CITY PLAN COMMISSION**THURSDAY, OCTOBER 19, 2023****FILE NUMBER:** S223-259**SENIOR PLANNER:** Sharmila Shrestha**LOCATION:** Hillcrest Plaza Drive, south of Lyndon B Johnson Freeway**DATE FILED:** September 22, 2023**ZONING:** NO(A)**CITY COUNCIL DISTRICT:** 11**SIZE OF REQUEST:** 7.452-acres**APPLICANT/OWNER:** 6700 LBJ Fwy, LLC

REQUEST: An application to replat a 7.452-acre tract of land containing all of Lot 1 in City Block B/7447 to create 3 lots ranging in size from 1.825 acre to 3.382 acre on property located on Hillcrest Plaza Drive, south of Lyndon B Johnson Freeway.

PRELIMINARY PLAT

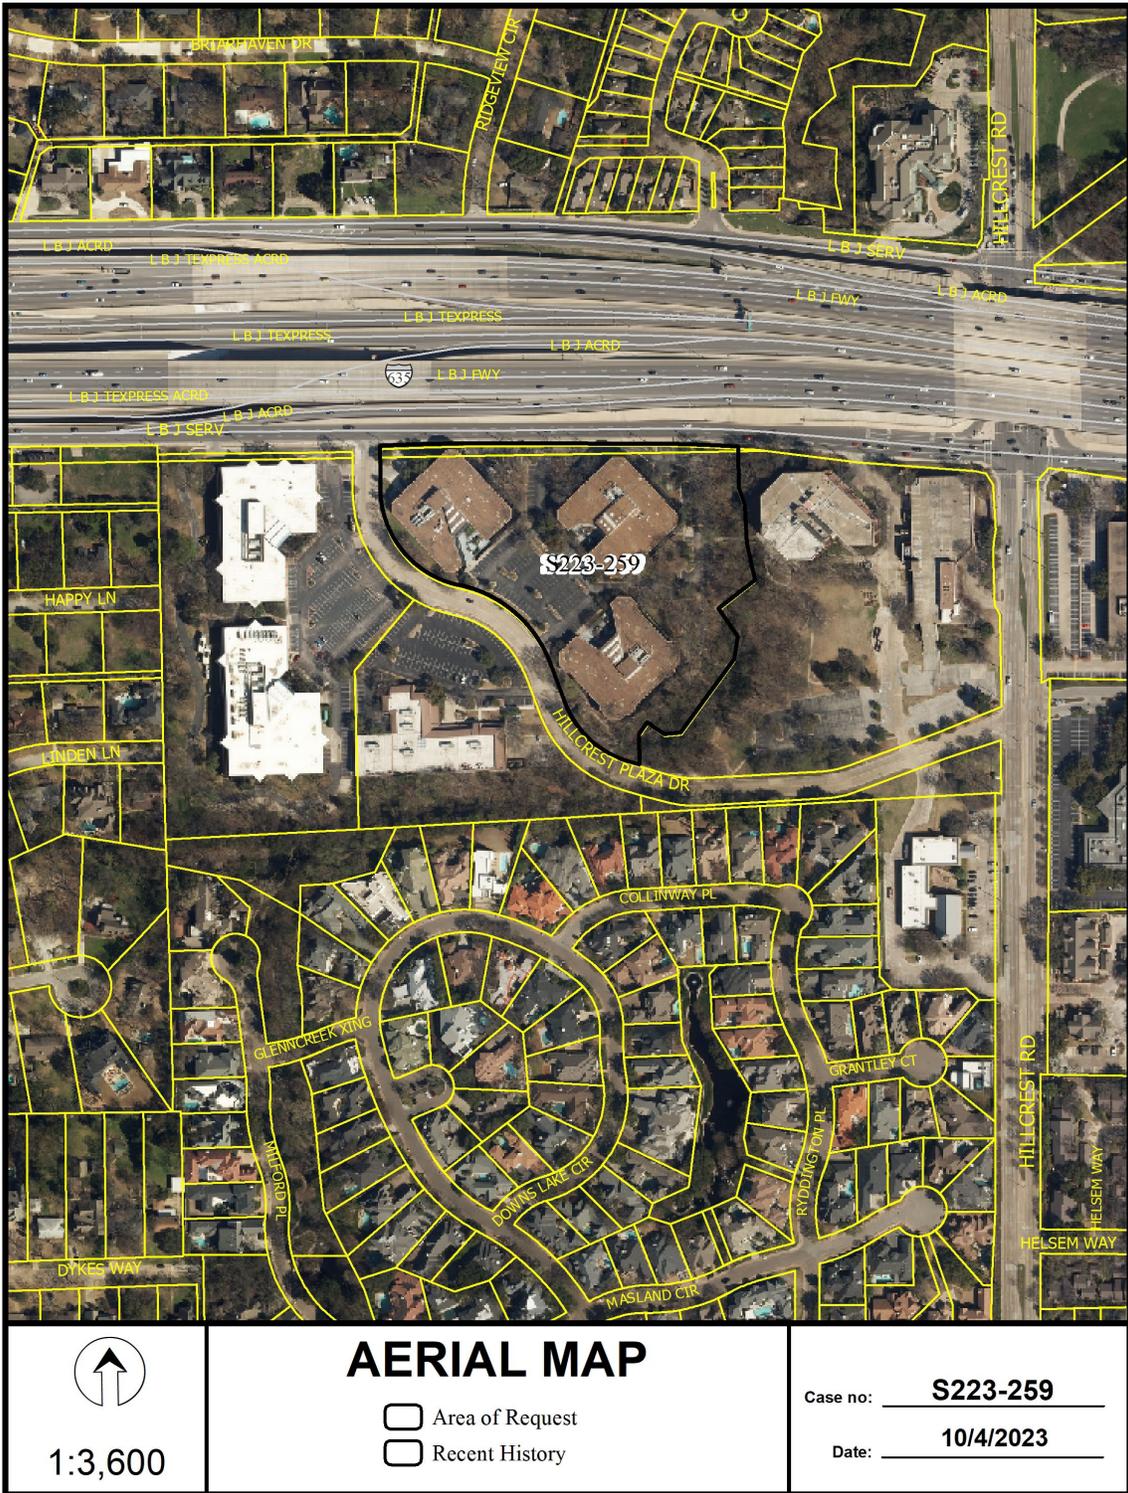
18. Prior to final plat, submit a completed final plat checklist and all supporting documents.
19. On the final plat, show recording information on all existing easements within 150 feet of the property.
20. On the final plat, show distances/width across all adjoining right-of-way.
21. On the final plat, show all additions or tracts of land within 150 feet of property with recording information.

22. Additional design information is required for assessment. Site plan must be submitted showing proposed development, building finished floor elevation, development, existing mains – including downstream manhole, and proposed water and wastewater service locations. Submit water/wastewater engineering plans to 320 E. Jefferson Blvd., Room 200, Attention: Water and Wastewater Engineering.

23. On the final plat, change “Lyndon B. Johnson Freeway (I-635 Service Road)” to “Lyndon B. Johnson Freeway/ Interstate Highway No. 635”
24. On the final plat, identify the property as Lots 1A, 1B, and 1C in City Block B/7447.
